Office Action Summary	Application No. 10/533,143	Applicant(s) SUGIURA ET AL.	
	Examiner Kwang Han	Art Unit 1795

FUEL CELL

DETAILED ACTION

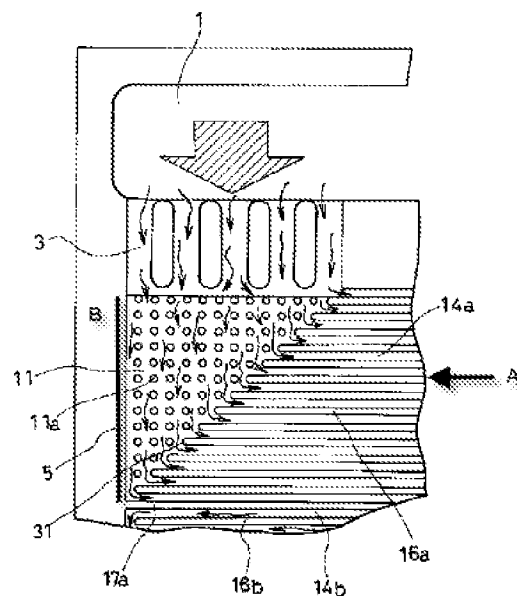
- (a) drawing 1 of the Sha reference shows the flow grooves 11 and 12 both having a triangular shape and basically of a inverted mirror image of the opposing side of separator. There is nothing to suggest that the outlet and buffer region of Sha do not have the same or close to the same size to form buffers which are substantially symmetrical as recited in claim 1,
- (b) the Sha reference does teach one side of the flow grooves 11,12 being substantially perpendicular to the terminal portions of the serpentine flow grooves as shown below in the figure:

The terminal portions all face in the direction of arrow A which is substantially perpendicular to the side B of the flow groove of Sha.

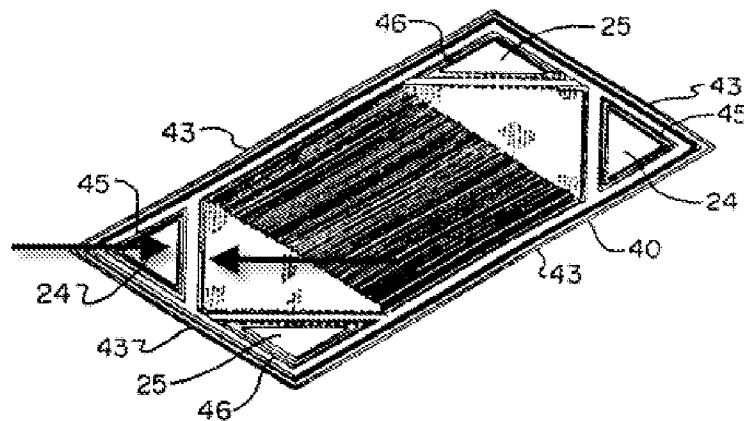
(c) as previously stated, the gas supply of Sha is silent towards the use of a gas supply passage with an oblique side. The Schora reference does teach that the oblique side of the gas supply passage faces the oblique side of the flow grooves of Schora as shown below in the figure:

As can be seen in the figure the oblique side of the gas supply passage faces the the oblique side of the flow grooves. When applying the teachings of Schora in combination with Sha it would have been obvious to one of ordinary skill in the fuel cell art to maintain or vary the orientation of oblique side of the gas supply passage to face the oblique side of the flow grooves to best direct the gas flow.
